**STAFF REPORT**  
**(Preliminary Plat)**

**CASE NUMBER:** S/D 99-83 -- HARVEST CHAPEL 2<sup>ND</sup> ADDITION

**STAFF REPORT**  
(Final Plat, Preliminary Plat Approved 12/2/99)

**CASE NUMBER:** S/D 99-83 - HARVEST CHAPEL 2<sup>ND</sup> ADDITION

**VICINITY MAP**

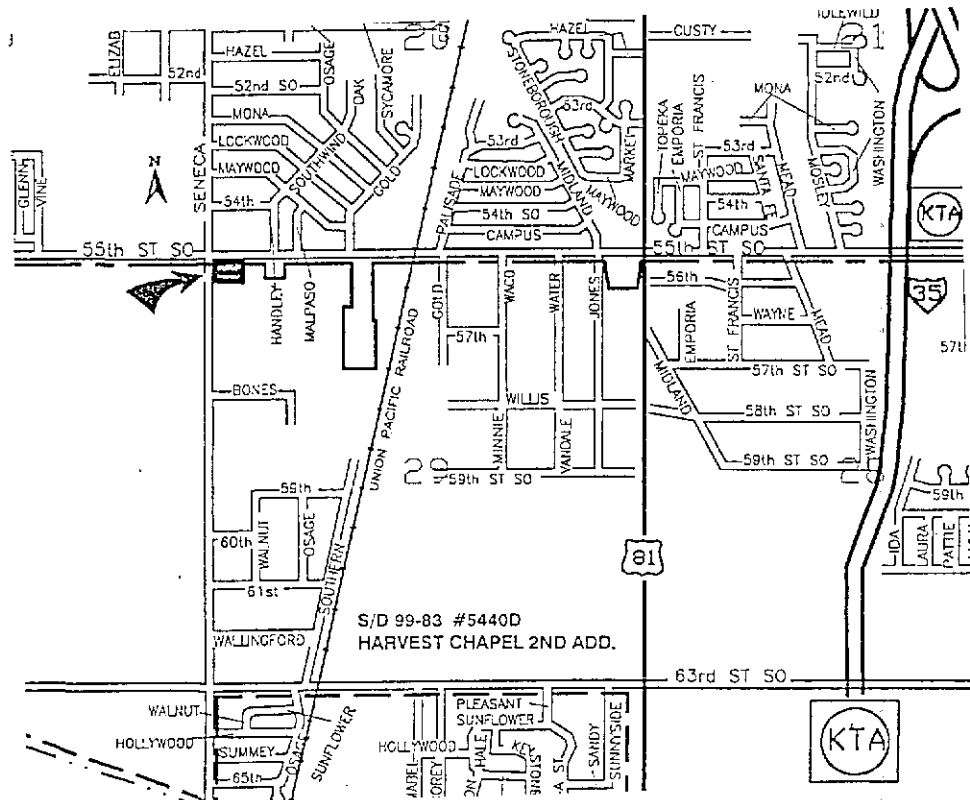
- A. Existing municipal services appear to be available to serve this site. City Engineering needs to comment on the need for any guarantees or easements.

- C. City Engineering needs to comment on the status of the applicant's drainage concept.
  - D. Traffic Engineering needs to comment on the access controls. MAPD requests shared access points with the adjoining properties to the east and south. A cross-lot access agreement is also requested to the benefit of the adjoining properties to the east and south. The plat proposes two access openings along 55th St. South and one access opening along Seneca. The plat also denotes 100 feet of complete access control along both perimeter streets from the intersection; although the Subdivision regulations require 150 feet of complete access control. Distances should be shown for all segments of access control. In accordance with the Subdivision regulations, access points are limited to right turns only within 250 feet of the intersection and should be denoted on the face of the plat. The final plat shall reference the access controls in the plat's text. The applicant shall guarantee the closure of any openings located in areas of complete access control.

- E. Prior to scheduling this case before City Council, the structure which encroaches into the street right-of-way being dedicated by this plat must be removed.

- F. If platted, the building setback may be reduced to 20 feet.
  - G. Traffic Engineering should comment on the need for improvements to perimeter streets.

**VICINITY MAP**

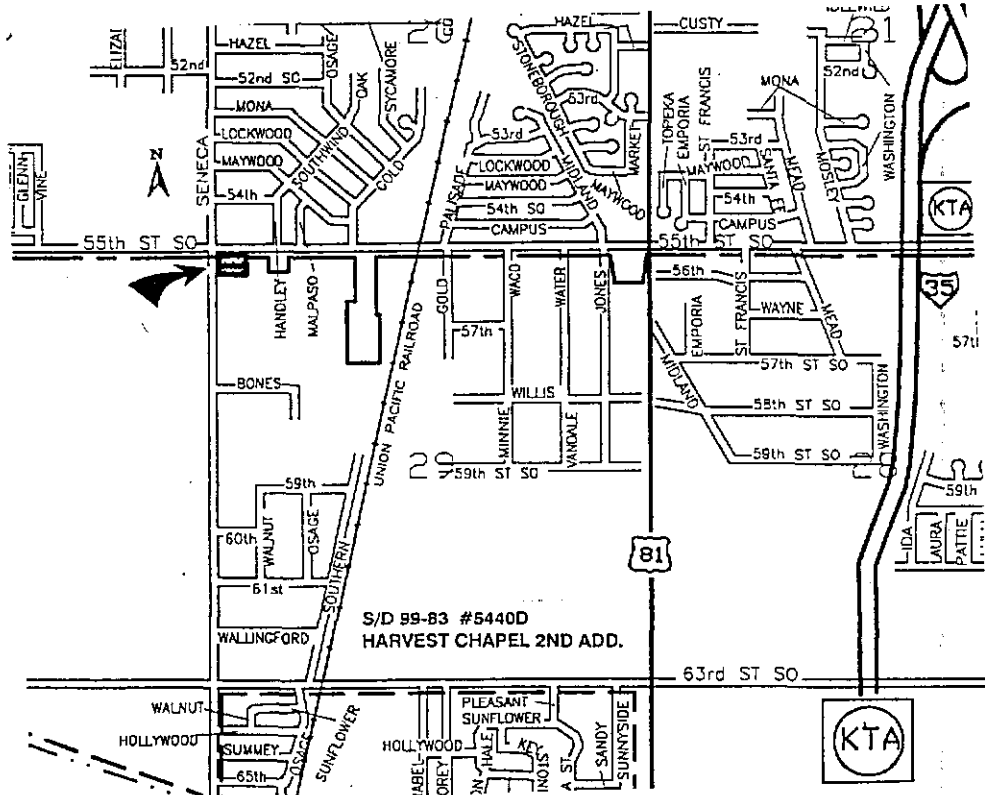
- A. City water is available to serve this site. City Engineering needs to comment on the need for any guarantees or easements.
- B. If improvements are guaranteed by petition, a notarized certificate listing the petitions shall be submitted to the Planning department for recording.

- C. City Engineering needs to comment on the status of the applicant's drainage plan.
- D. Traffic Engineering needs to comment on the access controls. The plat proposes two access openings along 55th St. South and one access opening along Seneca. The plat also denotes 100 feet of complete access control along both perimeter streets from the intersection; although the Subdivision regulations require 150 feet of complete access control. Distances should be shown for all segments of access control. In accordance with the Subdivision regulations, access points are limited to right turns only within 250 feet of the intersection and should be denoted on the face of the plat. The final plat shall reference the access controls in the plat's text. The applicant shall guarantee the closure of any openings located in areas of complete access control. Traffic Engineering requests an access opening to be located on 55<sup>th</sup> South along the plat's east line and on Seneca along the plat's south line.

- E. Traffic Engineering should comment on the need for improvements to perimeter streets. No improvements are required.
- F. The platting binder indicates that a mortgage is being held in this site. This party shall be shown as a signatory on the final plat tracing or proof provided that the mortgage has been released.

The requested access controls have been denoted on the final plat.
